RECEIPT DATE: 5/18/18 **ONSITE SEWAGE DISPOSAL SYSTEM**

PROPERTY ADDRESS: 1041 Fairlane Road

SUBDIVISION: Fairlane Farms

The OSDS Plan for 1041 Fairlane Road has been reviewed with the following comments:

**SEPTIC SYSTEM
INSTALLATION SITE PLAN**

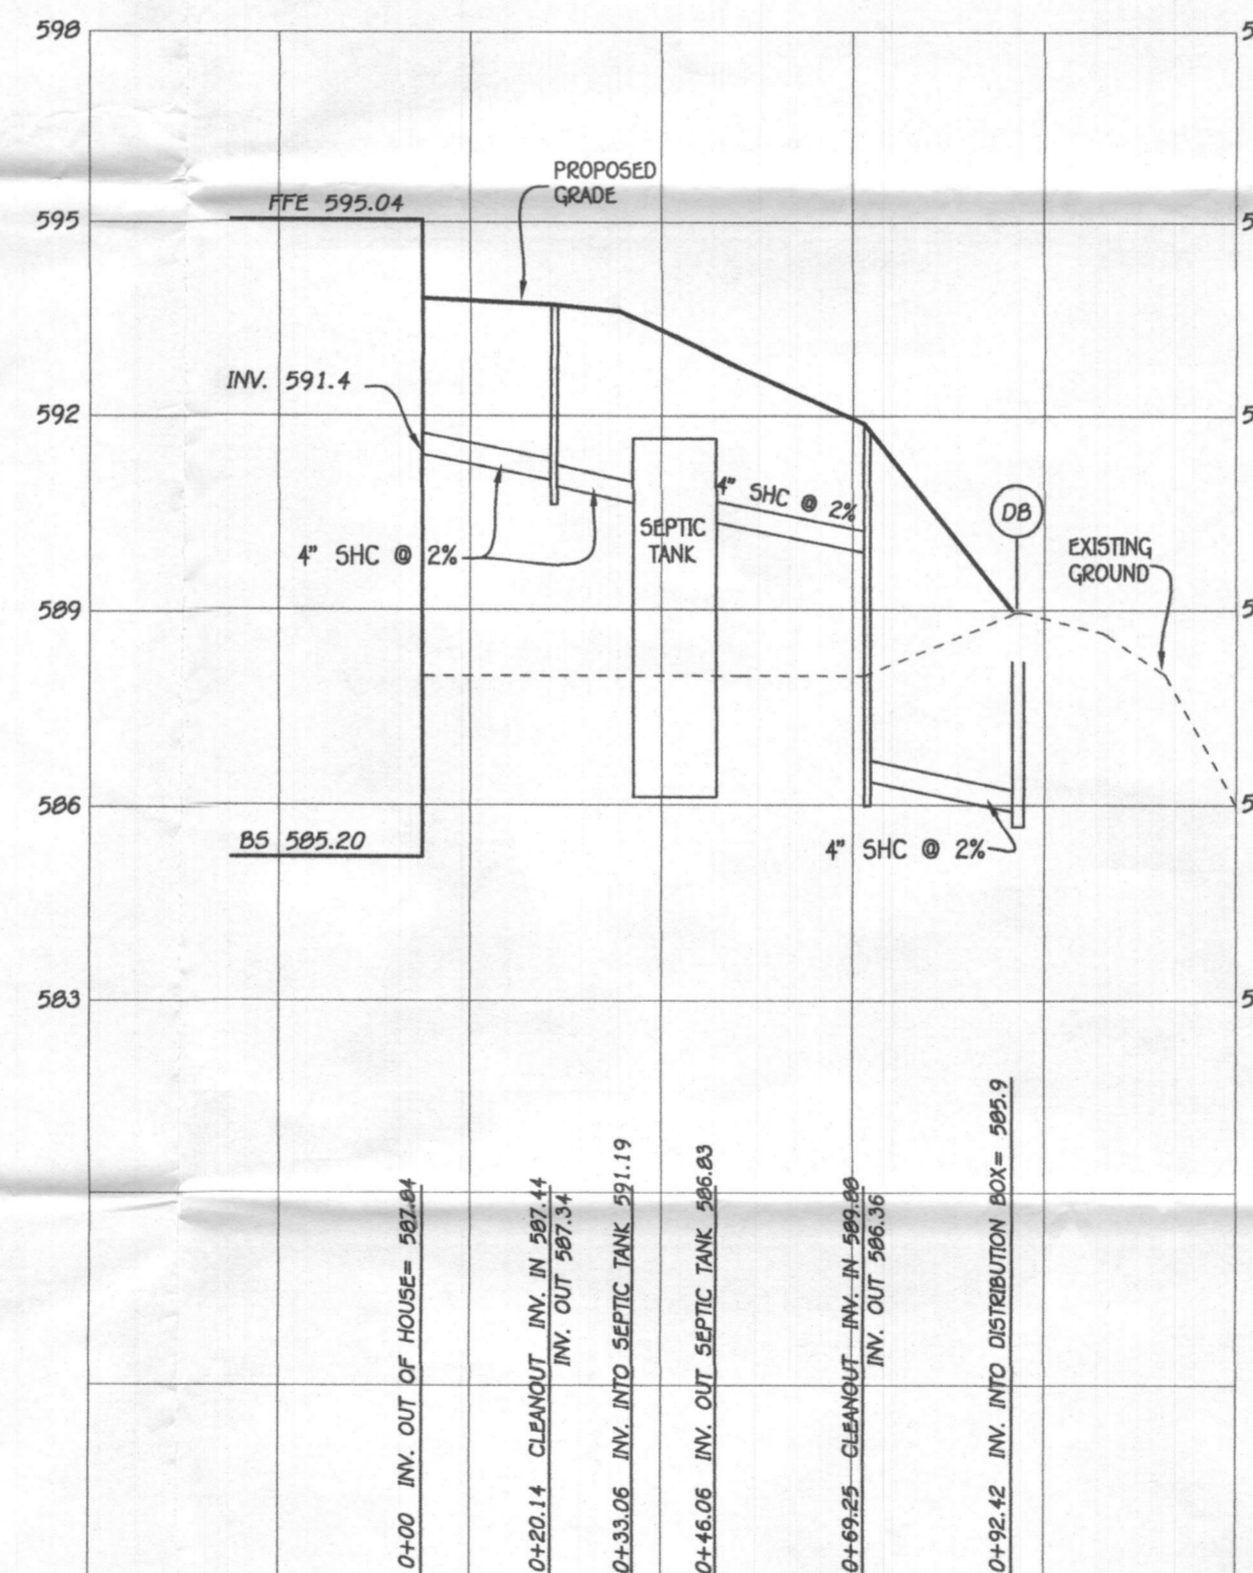
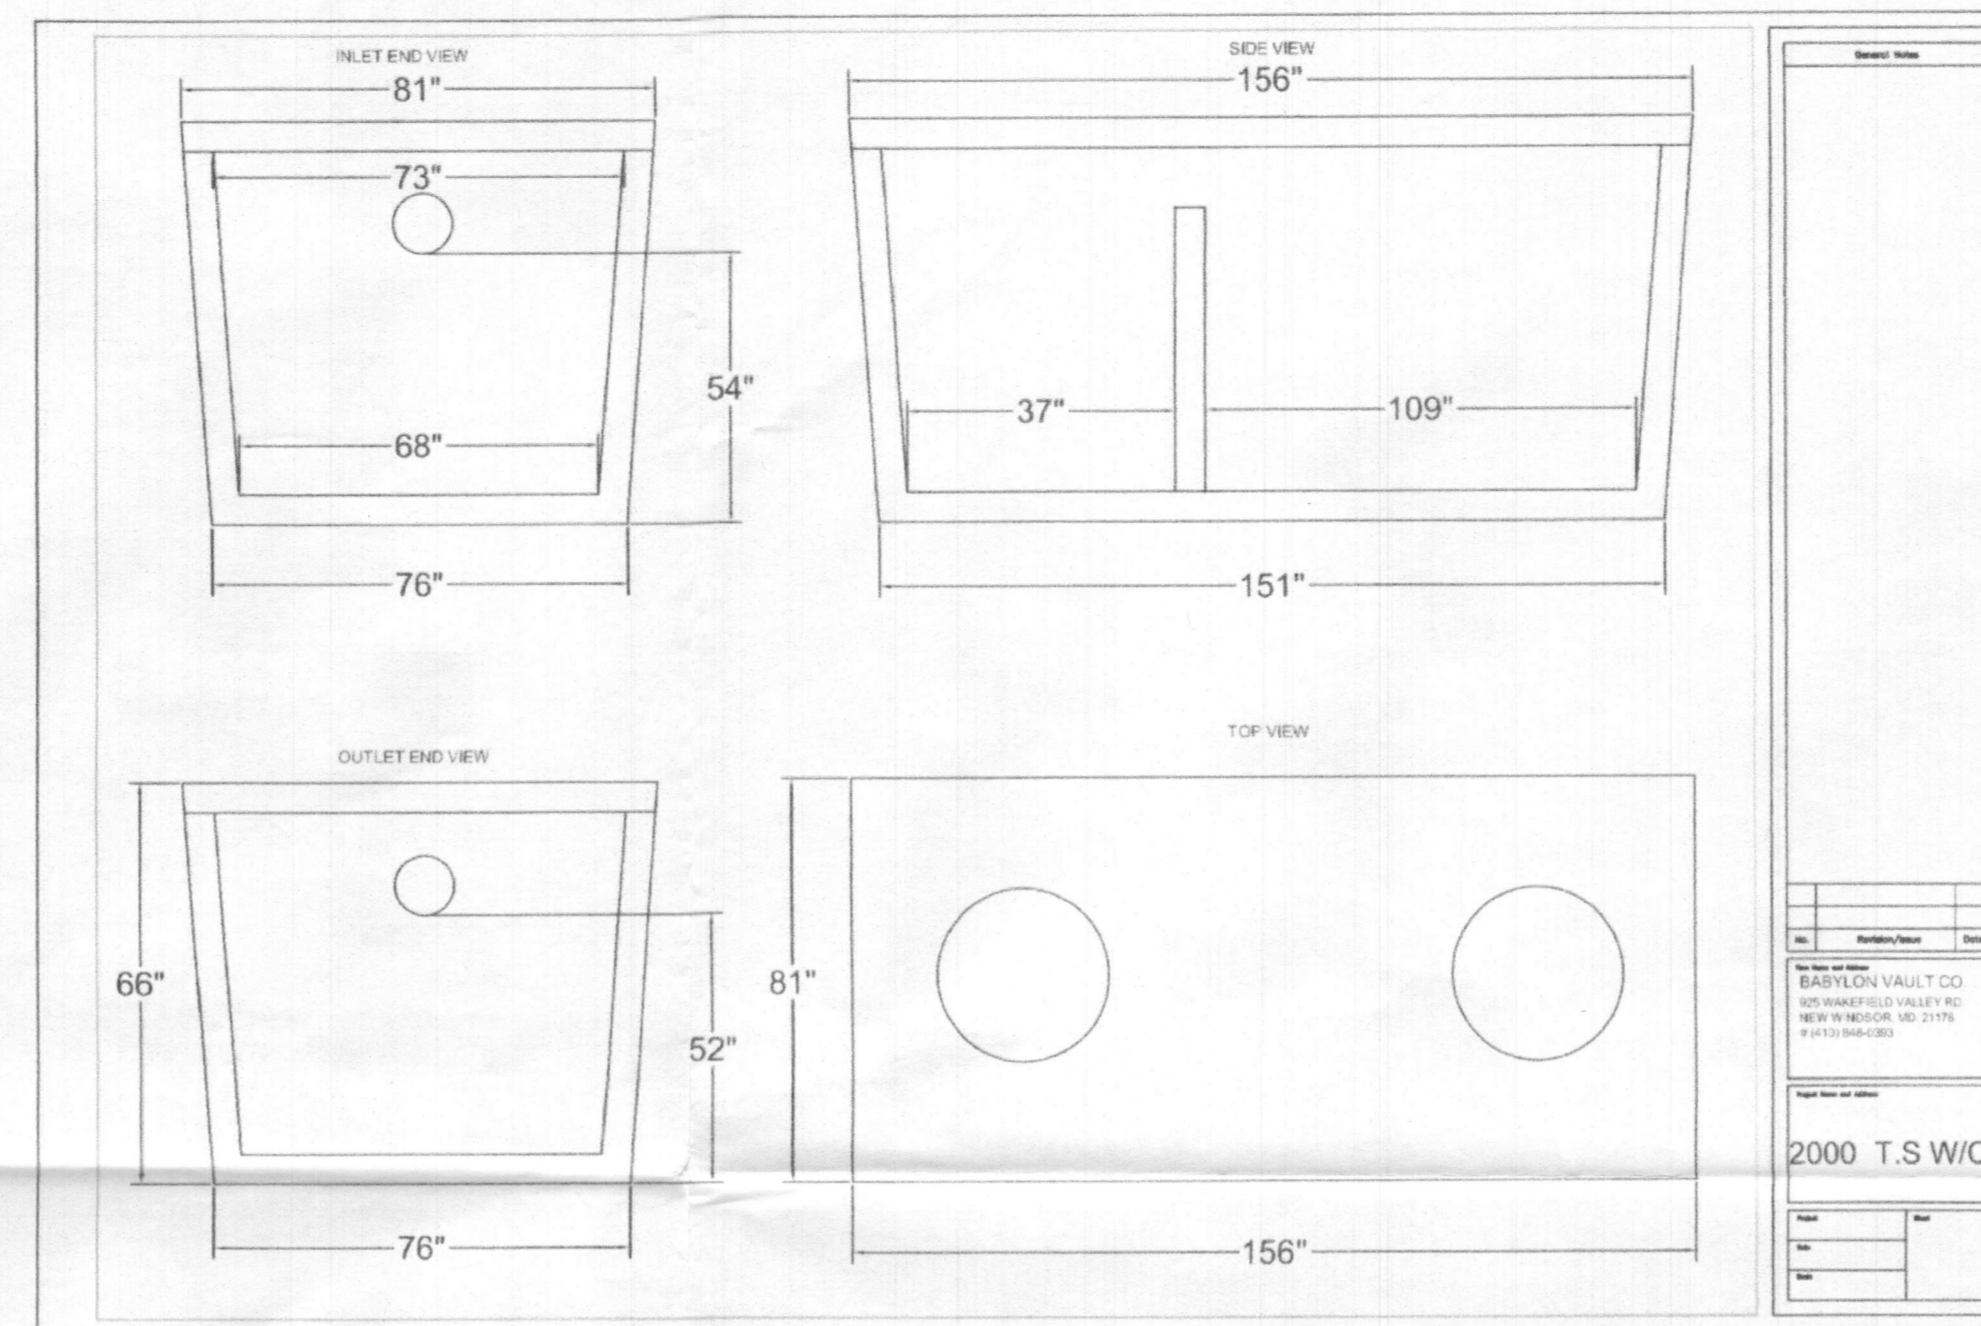
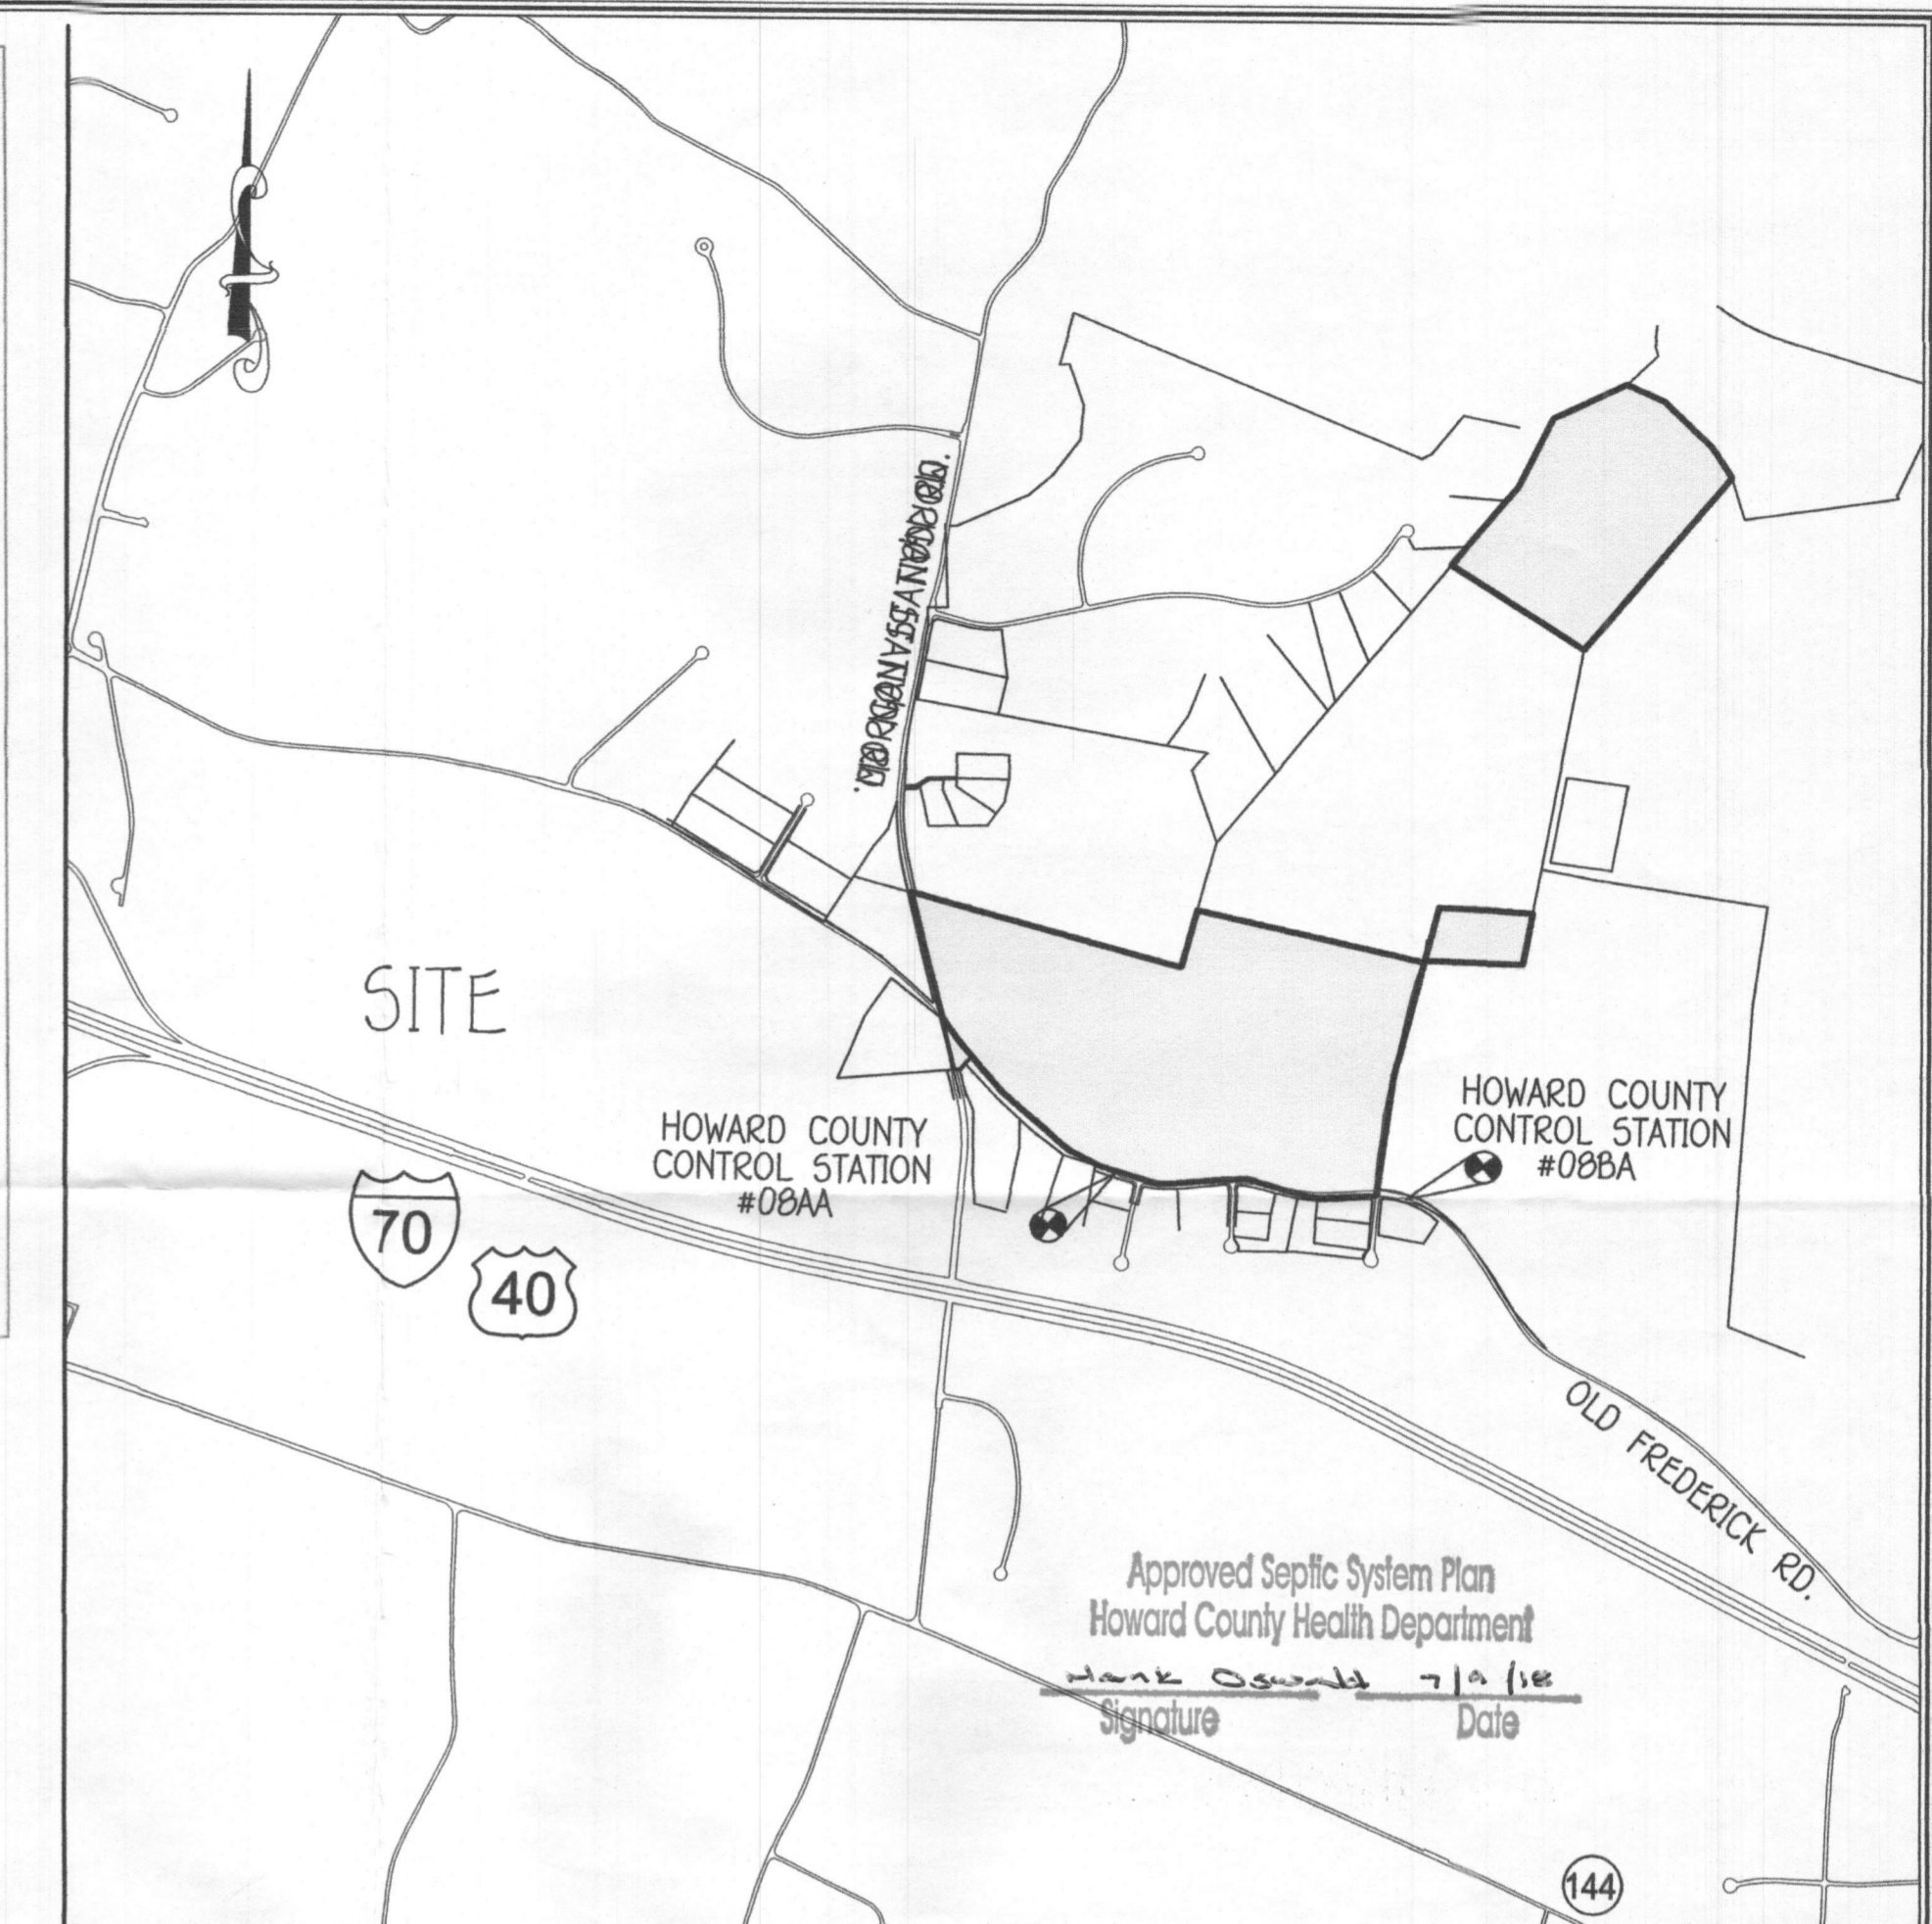
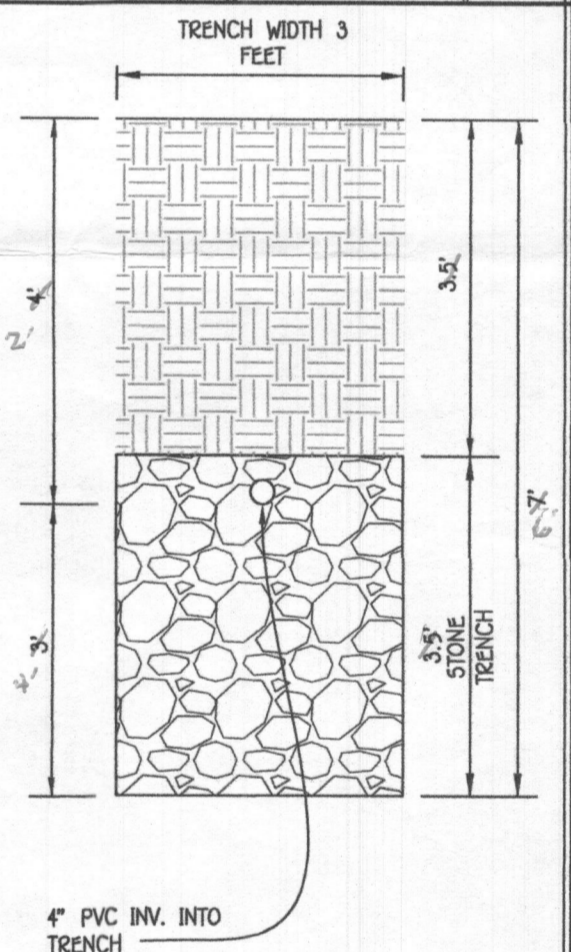
I spoke to Jeff about Lot 19. If you don't want a pump tank, then install the initial system at the very bottom of the SDA. If you add a pump tank then install the first system at the very top of the SDA. If you decide on not adding a pump tank, we would still like to see how one fits on the plan. You may label it future pump tank for replacement systems. Send me a revised pdf copy for review prior to sending hard copies.

I was at lots 19 and 20 of Fairlane Farm yesterday with South Carroll to layout the septic systems and had issues with fall. At lot 19, we cannot make the 4' inlet at the trenches with 2% fall in the pipe. The lowest the sewer line can be hung is 21" below top of foundation wall. We shot 71" relative elevation at the house sewer and 36" at the start of the first trench. It's an 80' run from the house to the first trench, so 19" fall for 2%. $71+19 = 90''$, which would be $90-36 = 54''$ at the first trench. The inlet at the second trench would be deeper because that trench starts at the end of the first trench. The current location of the tank is also near the swale cut into the yard near the SDA. If a pump tank is used, it would be better to put the tank and pump tank closer to the street in native soil (septic tank is currently surrounded by fill).
